## Planning Commission Staff Report

<b>Project Type:</b>	Site Development Plan
<b>Meeting Date:</b>	July 23, 2018
<b>From:</b>	Cassie Harashe, Planner 
<b>Location:</b>	14905 Clayton Road
<b>Description:</b>	<b>Mobil Mart at Baxter and Clayton (Brite Worx):</b> A Site Development Plan, Landscape Plan, Lighting Plan, Architectural Elevations and Architect's Statement of Design for a 1.72 acre tract of land zoned "PC" Planned Commercial District located on the western corner of the intersection of Clayton Road and Baxter Road.

The request is for a Site Development Plan, Landscape Plan, Lighting Plan, Architectural Elevations and an Architect's Statement of Design for a new 4,020 square foot stand-alone carwash facility at 14905 Clayton Road. The proposed building is to be constructed of EIFS and brick veneer with a stone base and a clear acrylic roof system. Accents include metal fascia, exposed steel ribbing, and clear glass windows. The subject site is zoned "PC" Planned Commercial District and is governed under the terms and conditions of City of Chesterfield [Ordinance 2977](#).

Figure 2: Buttonhook Screening Wall Location

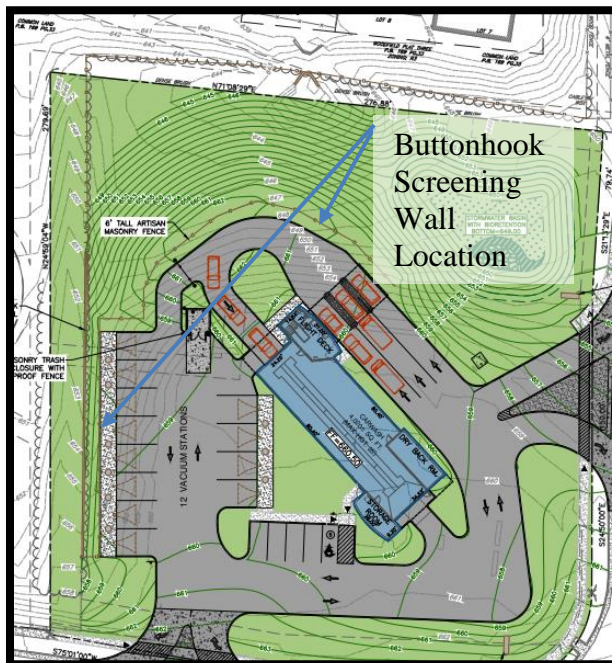
The Site Development Plan was reviewed at the July 9, 2018 Planning Commission meeting. At that time, there was discussion regarding the height of the screening wall around the buttonhook, as shown in Figure 2. The Commission requested to see section views of the site. The applicant has provided section views with sight lines that include both a 6' fence, as required by the site specific ordinance, and a taller 8' fence as requested by the Planning Commission.

The Site Development Plans still reflect a 6' wall. If the Planning Commission recommends approval with an 8' wall, the plans will be revised prior to the Planning and Public Works Committee Meeting.

Umbrella Arch Plan

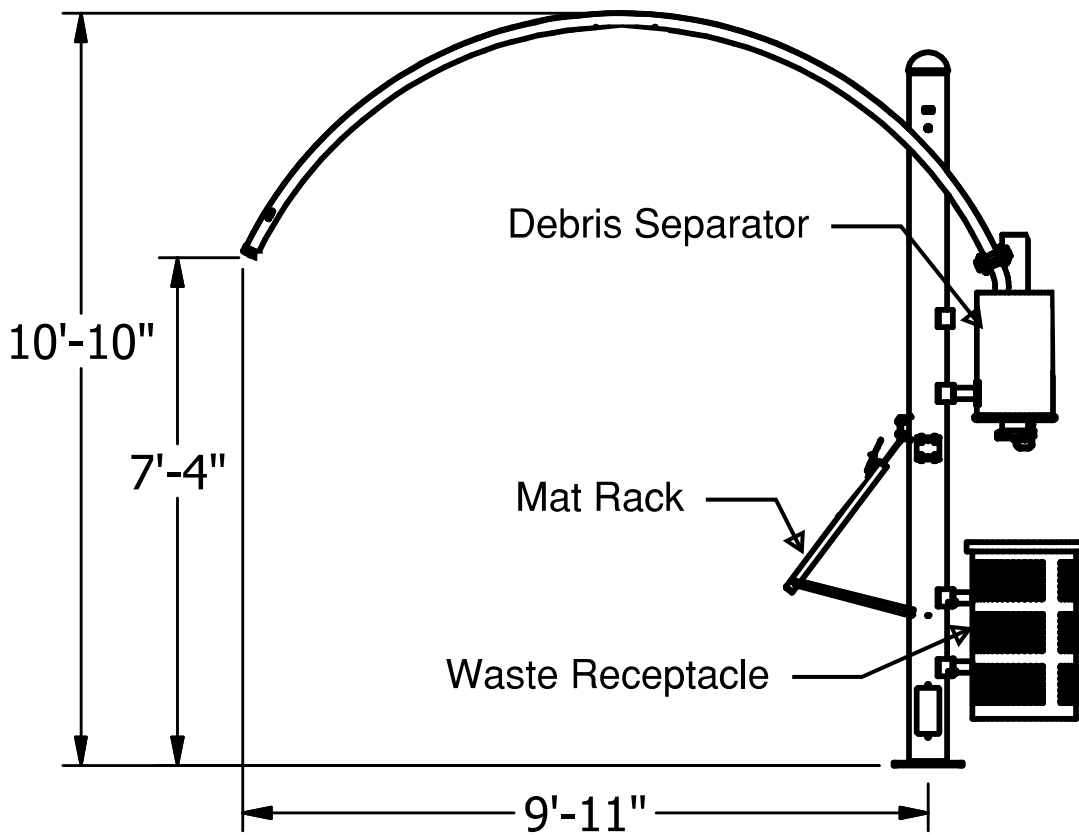
There was also considerable discussion regarding the accessory structures such as the vacuum balls and sun shades. The discussion resulted in a request that the applicant provide additional colors for these elements.

In response the applicant has submitted a different vacuum station that eliminates the ball element and the shade structure element. The new proposed vacuum stations will be placed on the stripe lines of the parking spaces and be 10' tall. The applicant is requesting the poles be blue. They have provided photos of the new vacuum station design. These are included with this report.

**TYPE:** PROPOSE 'UMBRELLA' ARCH (PHOTO ON THE LEFT) WITH POWDER COATED POSTS, ARCHES, AND OPTIONS IN BLUE *SIMILAR* TO THE PHOTO ON LEFT *BUT* USING THE SAME COLOR AS THE BLUE ACCENT ON THE BLDG.

- IN THE LEFT PHOTO, WE ARE PROPOSING TO SWAP ALL THE YELLOW FEATURES WITH THE BUILDING'S BLUE ACCENT COLOR BUT *WITHOUT* A CANOPY CLOTH
- THE PHOTO ON RIGHT SHOWS THE 'PALM' ARCH, NOT THE 'UMBRELLA' ARCH WE ARE PROPOSING, BUT SHOWS THE STATIONS W/O A CANOPY CLOTH USING *SIMILAR* COLORS *EXCEPT* WE ARE PROPOSING *ALL* BLUE (IN LIEU OF BLUE CANOPY CLOTH).

Figure 5: Color Elevations

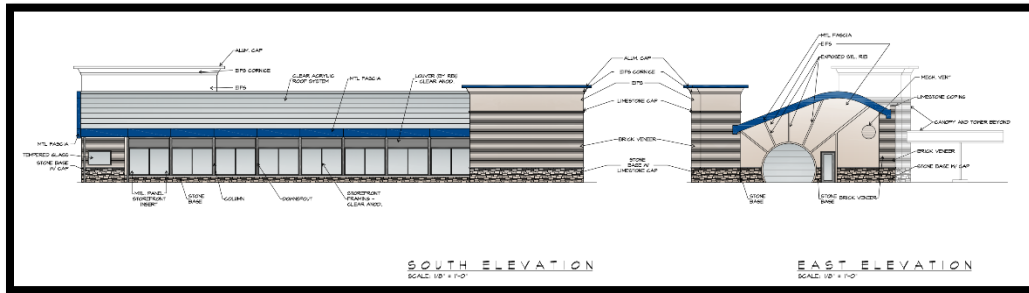
The Wallis Company in one of our meetings assured us that the architecture of this tunnel carwash would not look like the prototype Briteworx on Lindbergh Rd. They even promised us they would use building material that would make it resemble the center where the restaurant Mia Sorella is located. That way it would blend with our neighborhood and not look like it belonged on Manchester Road. We were at the last architectural meeting and the renderings of this Briteworx Carwash look to be extremely similar to the one on Lindbergh. There was no toning down of the garish blue detail.

Please require that they reduce, if not eliminate, the gaudy bright blue trim. Add more brick similar to those used in the commercial buildings on the south west corner of Clayton and Henry. The rendering of the Clayton and Baxter Briteworx does not reflect what the signage will look like and where it will be located. That is an important factor that needs your review.

Figure 6: Screening Wall & Fence Locations

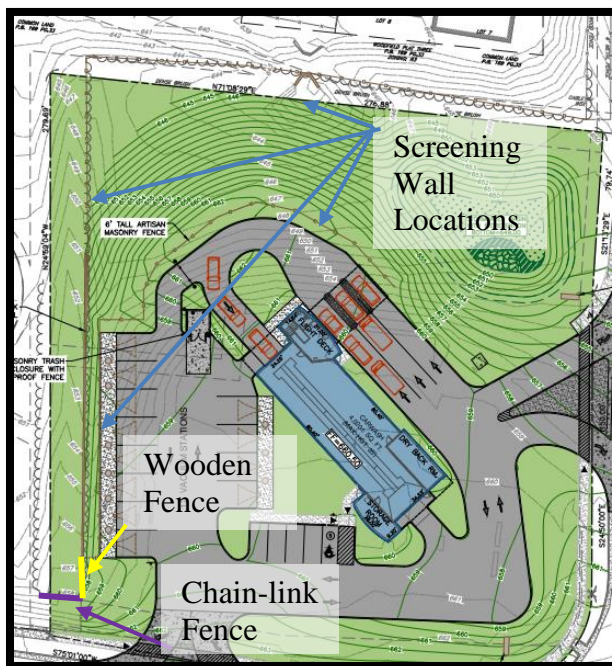
Per the requirements of Ordinance 2977, the site should have an artisan concrete screen wall along the western edge of the vacuum station that continues to wrap around the northern side of the drive aisle around the development. The Ordinance also has a requirement that an artisan concrete wall be installed along the northern property line. The Site Development Plan shows the required wall, along with an artisan concrete wall that connects the northern wall to where the wall turns at the vacuum stations, essentially providing a continuous wall along the western and northern property lines. The locations of these walls are indicated by blue arrows in Figure 6.

At the southern end of the vacuum stations, the artisan wall will end and tie into a portion of the existing wood fence. The wooden fence is currently parallel to a large portion of the western property line. This fence will be removed, except for the portion indicated in yellow in Figure 6. This wood fence connects to an existing chain-link fence; approximately 13' of this fence, shown in purple in Figure 6, carries over onto the subject site from the southern property line of the Woodfield Development. The existing conditions of these fences can be seen in Figure 7.
